## BOARD OF ADJUSTMENT MEETING AGENDA

OCTOBER 3, 2023

## Woodspring Suites

## Cottages at Magnolia East

2 BUILDING TYPE IV - REAR ELEVATION  
 1/8" = 1'-0"

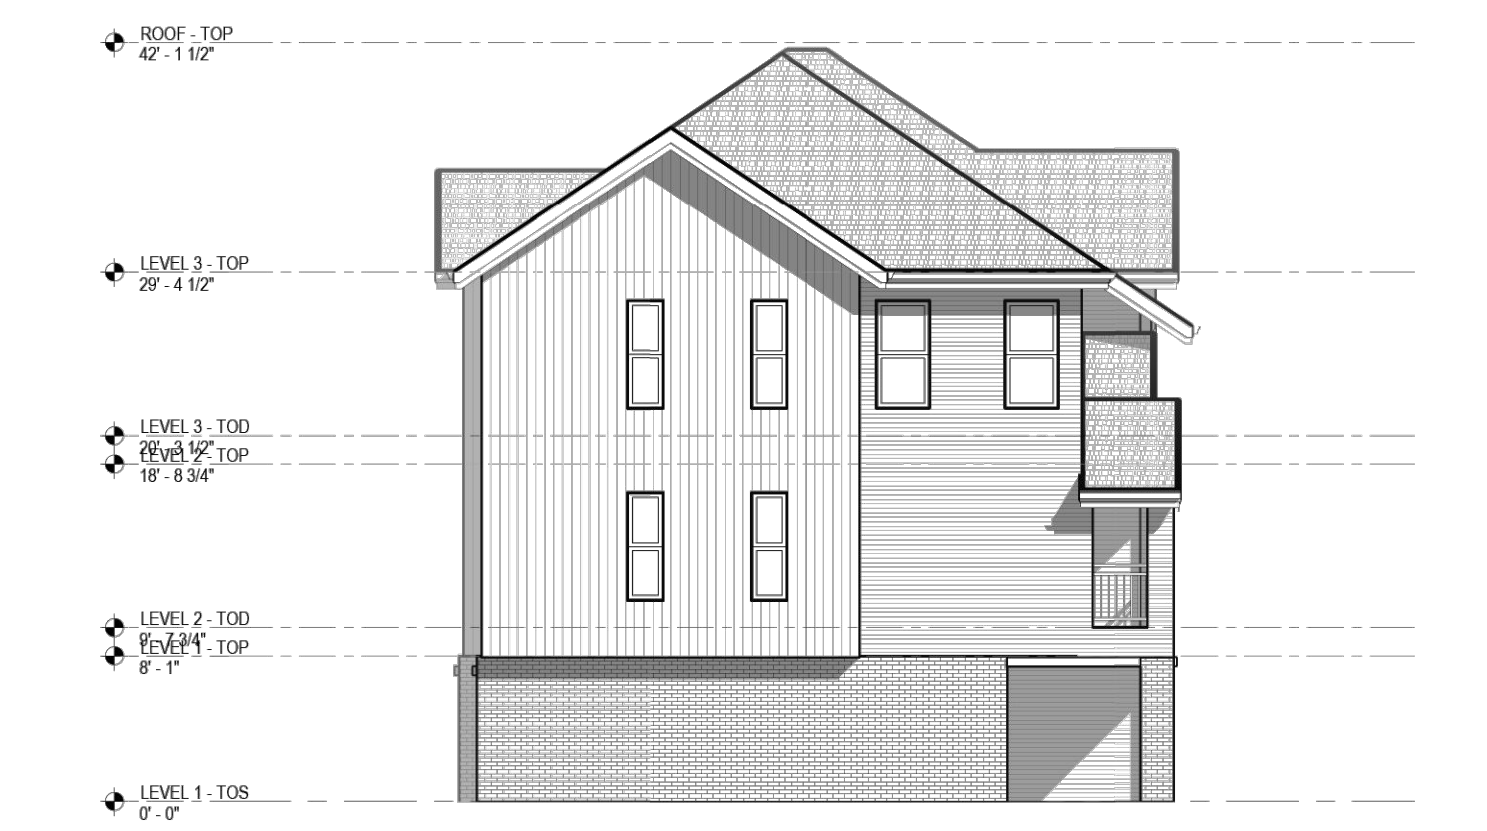
- To vary Sec. 14-732(4.5)(c)(i), which requires a first floor height of 12' for all frontages in a U-NBT development
- Proposed height of first floor in all units: 8'1"

- U-NBT zoning requires 12' first floor, to account for the possibility of a commercial use on the first floor.
- Development is proposing 8'1" first floor.

- Lot fronts S 43<sup>rd</sup> Street, a minor street that parallels S Promenade Blvd, a major arterial.
- Proposed development is being built to the urban form that URDC calls for, while also featuring garages and street parking.
- Subject property is designated for NBT growth, within the commerce corridor. This is intended to act as a residential buffer between potentially intense commercial uses in Commerce Corridor and adjacent Neighborhoods.
- Staff cannot guarantee that future developments in the area will contain commercial uses.

- S 43<sup>rd</sup> Street functions more as a side street, compared to an arterial like S Promenade. Not very much commercial viability within NBT form at this location.

- Proposed development utilizes urban form, street parking and garages and features no surface parking, while providing efficient housing. *“The purpose of the Uptown Neighborhood Transition zone is to provide medium- to high-density residential infill between the other URDC zones and surrounding existing residential neighborhoods. U-NBT development is typically characterized by residential structures that are single-family, 2- to 3-stories, with very small or zero side setbacks, such as brownstones, townhomes, garden homes, or similar housing types that normally feature front on-street parking and rear- or side-entry garages.”*

- Commerce corridor has an NBT buffer designated along its edges to protect adjacent Neighborhoods from potentially intense C-2 or C-4 developments.
- In this area, the applicants have several multifamily/townhome developments under way. Staff recently received a mixed use medical and commercial development request just northwest of the subject property. Staff has not seen a full master plan for the area.

- **APPROVE** variance for first floor height reduction

- Staff recommends approval of the request.
